**Errata for the
PCI Express[®] Base Specification
Revision 3.1,
Single Root I/O Virtualization and
Sharing Revision 1.1,
Address Translation and Sharing
Revision 1.1, and M.2 Specification
Revision 1.0**

September 18, 2015

Figure 7-3: PCI Express Configuration Space Layout

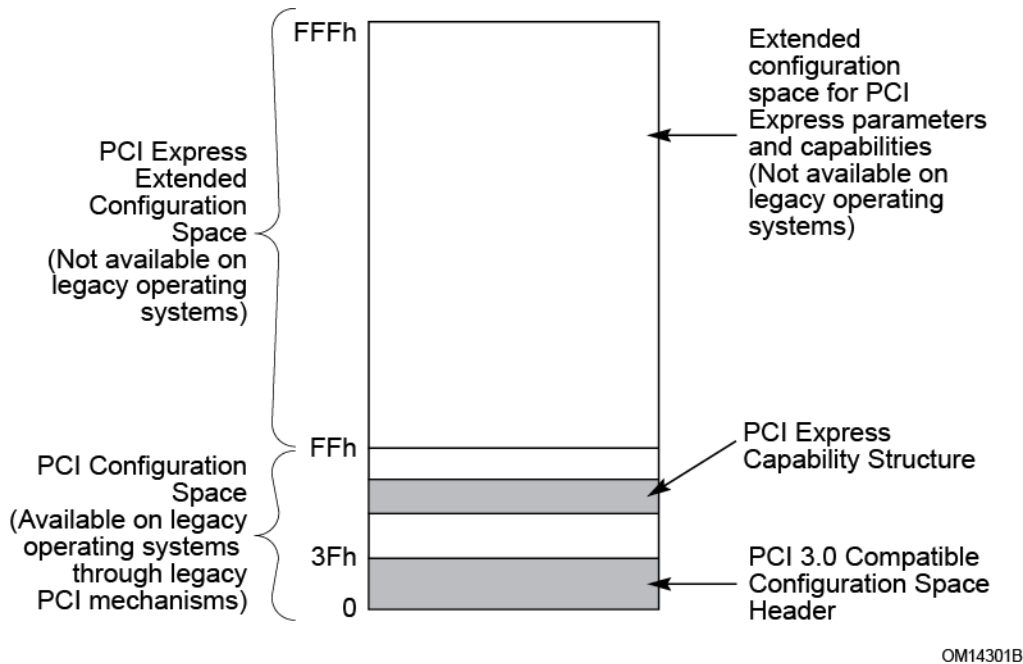
In Section 3.5.2.1, page 655, Figure 7-3, change text as following:

PCI Express
 Capability Structure
~~Capability needed by BIOS
 or by driver software on non
 PCI Express aware operating
 systems~~

so the figure becomes the following:

Figure 7-132: Secondary PCI Express Extended Capability Structure

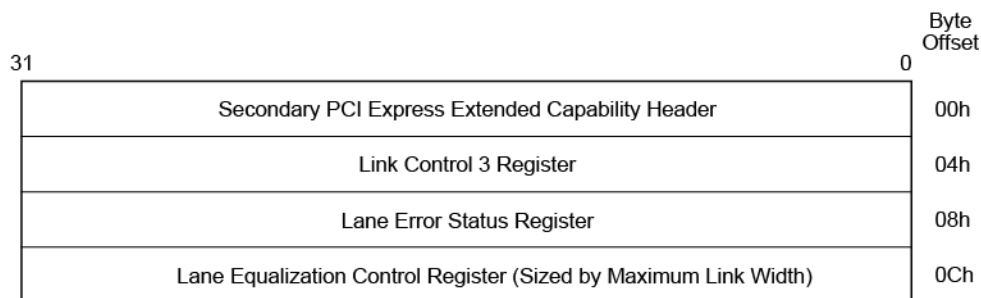
In Section 7.27, page 857, Figure 7-132, change the name of the field at offset 0Ch as follows:

Lane Equalization Control Register (Sized by Maximum Link Width)

so that the figure looks like:
